Product Name:	FlexLock Receptacle	
	10158558 - 28p / 36p	
Product Manager:	Jennifer.Zhang@amphenol-fci.com	
Subject:	Enter PCN distribution listing i.e., Global or name of customer(s)	
Distribution:	Affected customers	
Type of Change:	Notification of Change with Immediate Effectivity	
Change Description:	Add QR code on the bottom surface of connector	
Reason for Change:	To track contact spring dimension 0.20mm+/-0.05mm by QR code quality tracing	
Affected Parts:	See Affected parts.xls file	
Effective Date of Change:	August,01 2025	
Last Time Buy Date:	NA	
Earliest Disty Return Date:	NA	
Last Time Shipment Date	NA	
Datasheet Attached?	Yes	
Qual/Test Data Attached?	Yes	
Samples Availability Date:	01 August ,2025	
Available Alternatives?		
Questions?	Contact your local ACS Representative, or Product Manager	
	Jennifer.Zhang@amphenol-fci.com / Product Manager

10158558
QR CODE

FlexLock 10158558 28p/36p

QR code introduction For 10158558

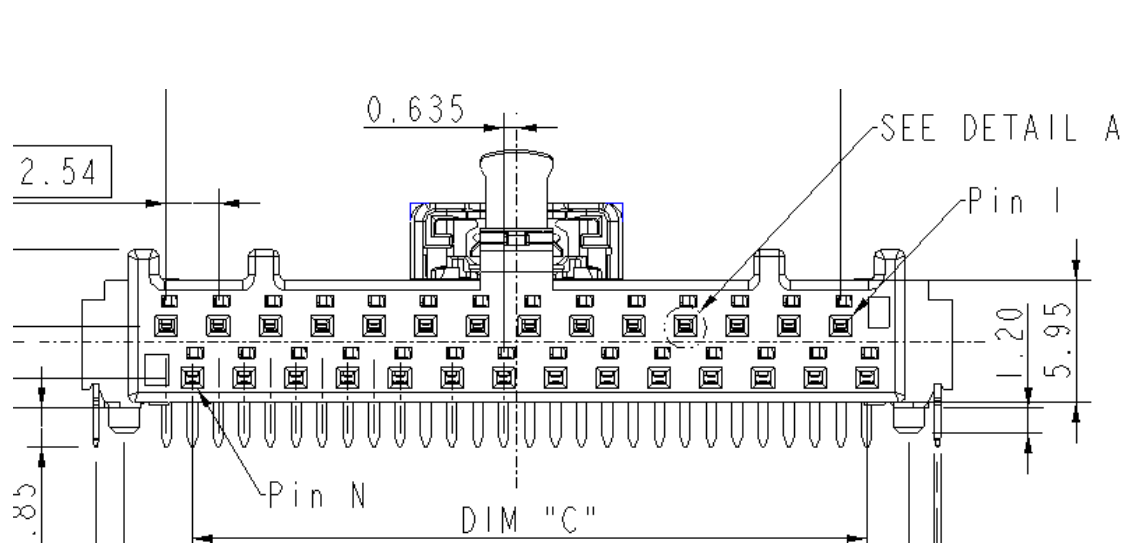
The dimension 0.20 ± 0.05 on the terminal is important to function.
So we record it for the every product 10158558.

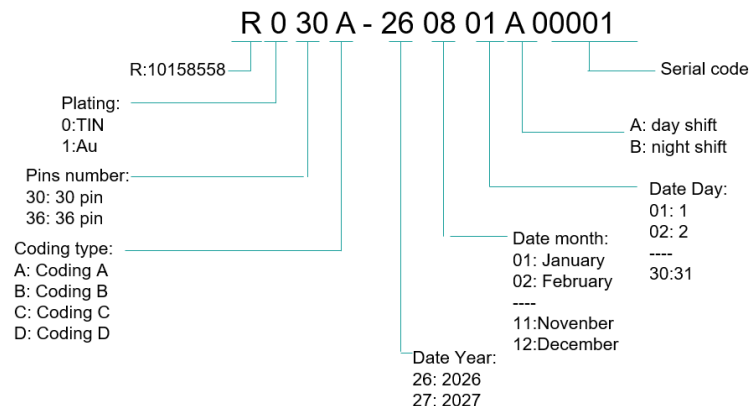
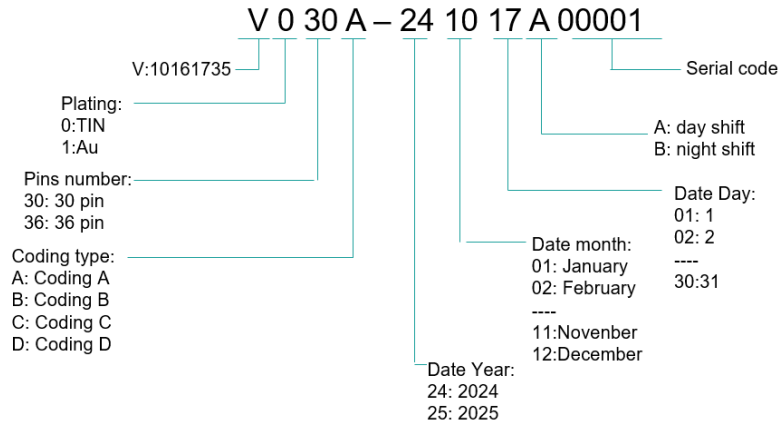
在产品底面增加QR 码，便于追踪此产品的端子弹片gap 0.20+/-0.05 尺寸记录。

Add QR code on the bottom surface, and then we can track the contact spring dimension 0.20+/-0.05 of this connector.
